HISTORIC PRESERVATION BOARD

**PUBLIC HEARING
5 INDIA STREET**

TO: Chair Sheridan and Members of the Historic Preservation Board
FROM: Deb Andrews, Historic Preservation Program Manager
DATE: February 28, 2019
RE: March 6, 2019 **PUBLIC HEARING**

Application for: **Certificate of Appropriateness for New Construction**

LANDSCAPE
AND LIGHTING
PLAN

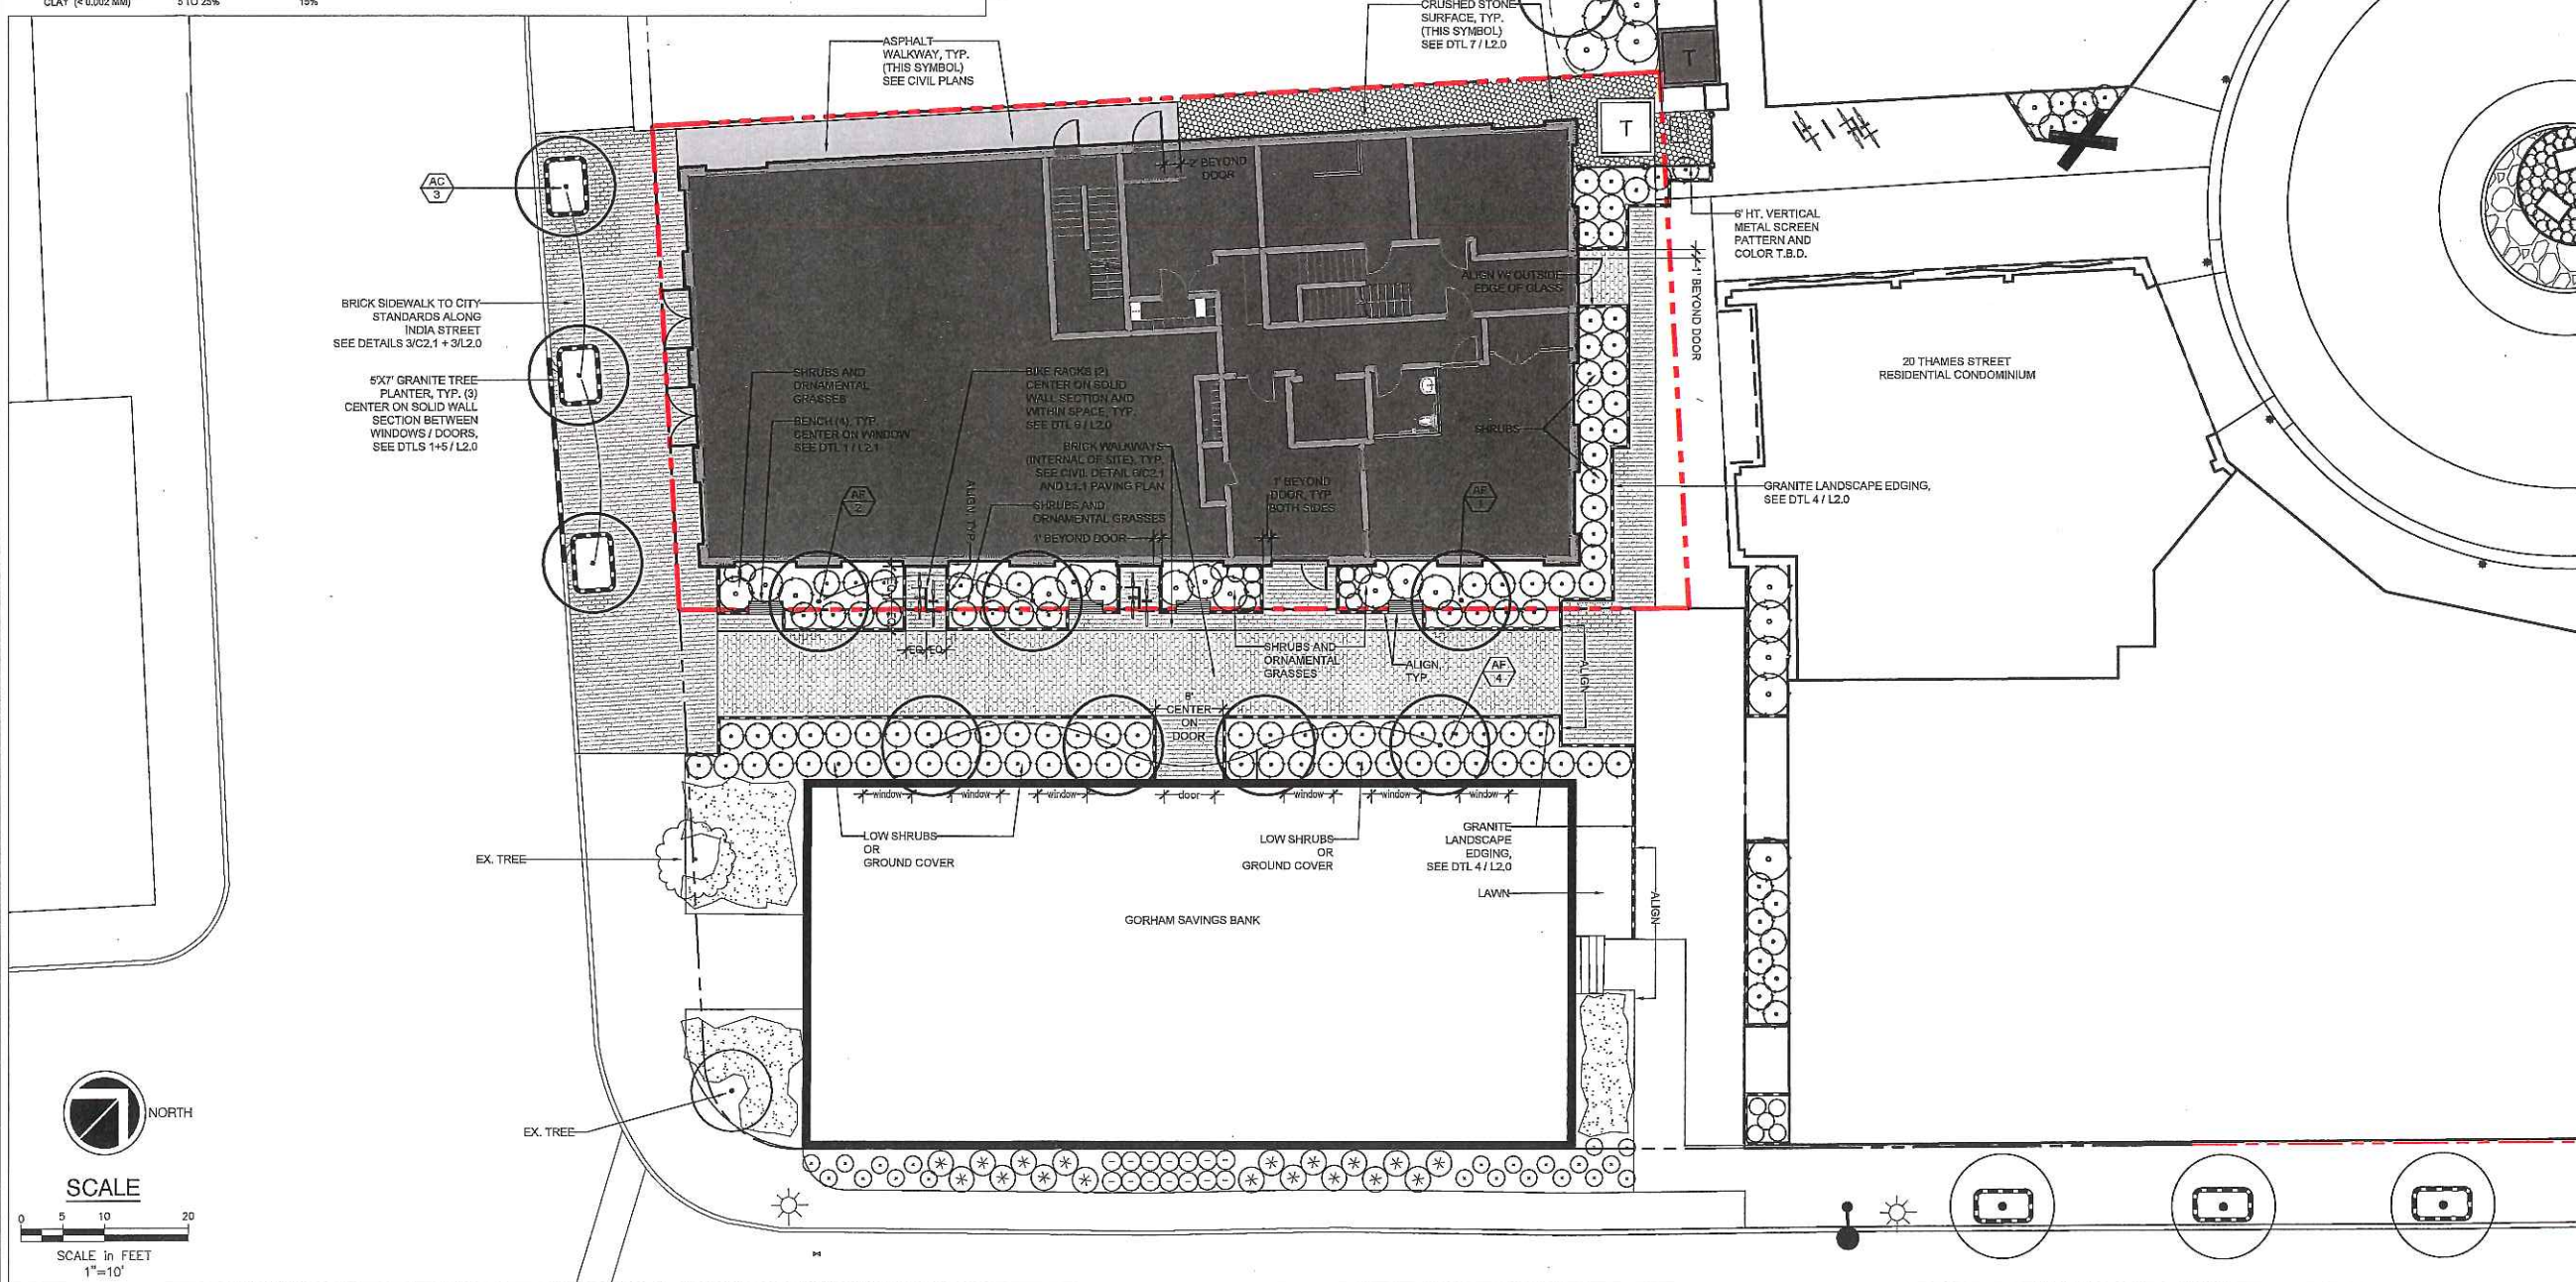
7. *Reference is made in the project narrative to the applicant's plans to create a courtyard and public way between the new building and the Grand Trunk building. Project architects will need to provide a detailed site plan for this area, as this component of the project also requires HP Board review.*

See included master plan and rendered site landscape plans included in the PDF drawing set. See narrative and supporting documents included in this document.

PROPOSED ELEVATION:
INDIA STREET

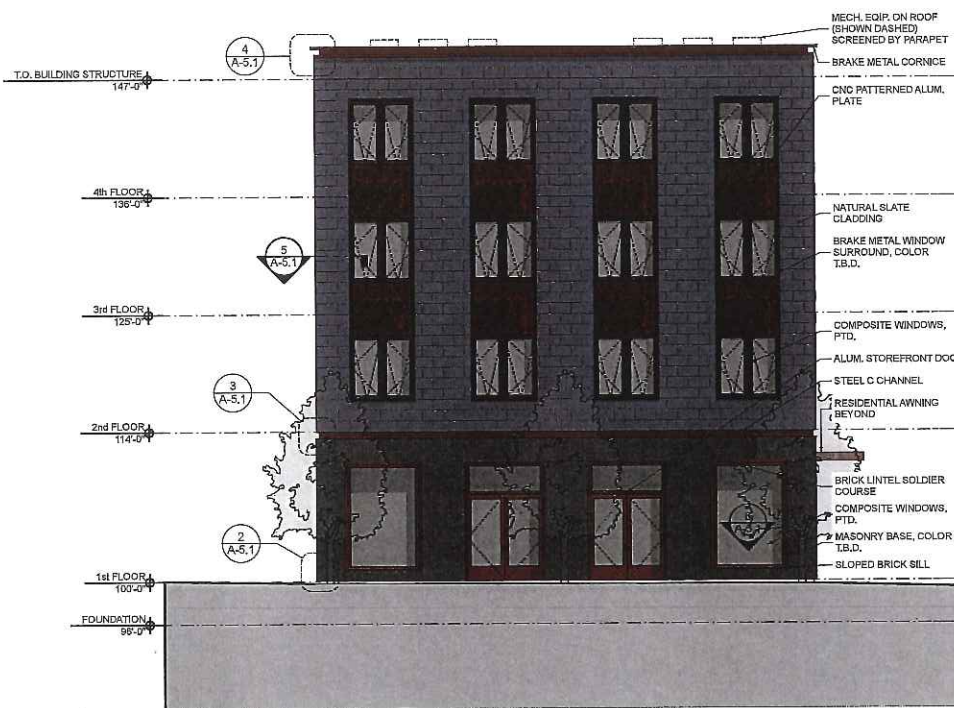
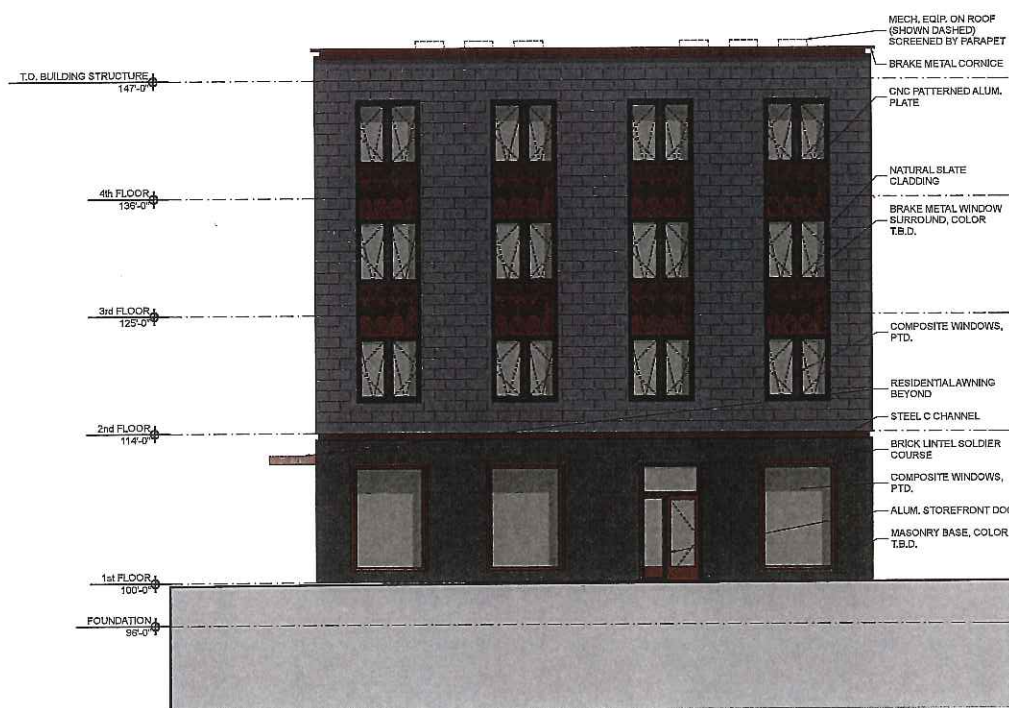
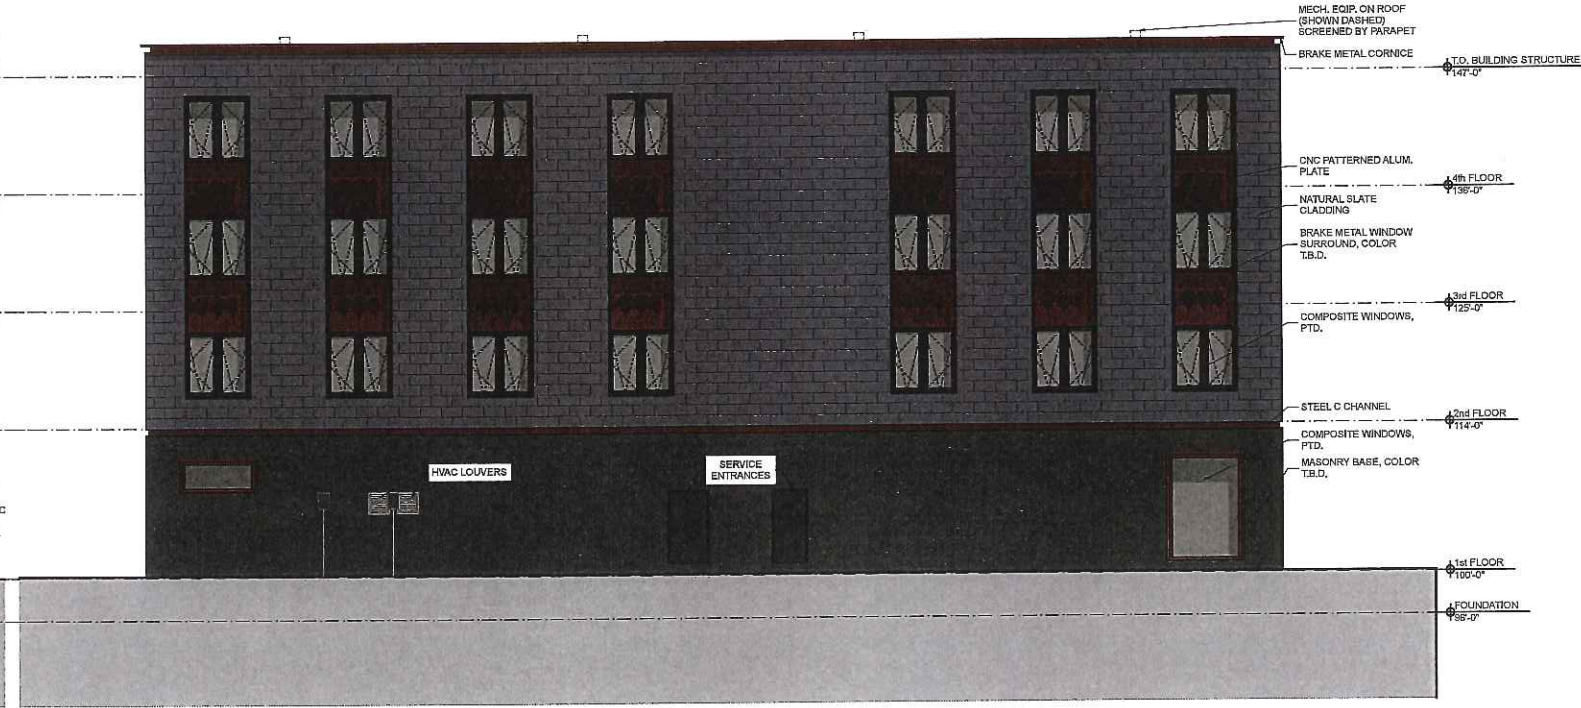
Regarding the exterior material palette, staff had raised a question in the staff report about the proposed material palette, noting that red brick was identified in the India Street Historic District designation report as an important unifying visual characteristic of the street. Staff also noted that given the currently fragmented nature of this gateway block of India, the use of red brick could help to strengthen the relationship between the upper and lower ends of the street. Notwithstanding these considerations, the Board expressed support for the applicant's proposed material palette, noting that the materials were consistent with the overall design aesthetic, that natural slate would age/patina over time and that the materials were of a quality commensurate with the building's historic context.

- Questions were raised about the lack of any foundation or datum to express a building base.
- Questions were raised about the finish of the stainless-steel clips that would secure the slate. Were they to be black have a natural finish? (Several members expressed a preference for natural.)

- Additional information and/or material sample was requested for the patterned aluminum plate. Board members had questions about the proposed finish, color and pattern.

- A Board member asked that consideration be given to taller windows on the upper floors.
- Board members requested that a detailed site plan be provided with the final submission. Also, the plans should indicate any exterior lighting and a spec be provided.

6. *The notes on the elevations indicate that vinyl windows are proposed for the upper floors. While there are numerous options available today in vinyl or composite windows, the quality of the window and its visual character warrant careful consideration. The project architect should be asked to provide additional information to satisfy any concerns the appropriateness of vinyl windows in this context.*

We will provide a sample of the color and sheen, but we are unable we cannot provide a complete mock-up of the patterned panels at this time. We are evaluating a dark bronze anodizing, and a bronze powder coat paint finish. The goal is to maintain a subtle and elegant color palette building wide, with architectural metals consistently in the dark bronze color family. We have taken into consideration from the board as to patterning only the India Street facade. Until we have a better

The intention of the proposed base condition is to keep the connection between the ground plane and the vertical wall quiet and clear. We are not proposing a plinth base set proud of the brick. We want to maintain a clear transition from the horizontal traditional red-brick sidewalk to the dark vertical wall of the building without exposing a concrete foundation or negative reveal. We intend to avoid adding a new or different material for this sole purpose. Due to the cross-sloping grade along the India street facade, there will be several steps in the foundation wall. However, the intention is for the brick to terminate into at the base with a small black metal weep flashing just above the brick sidewalk for drainage behind the brick veneer.
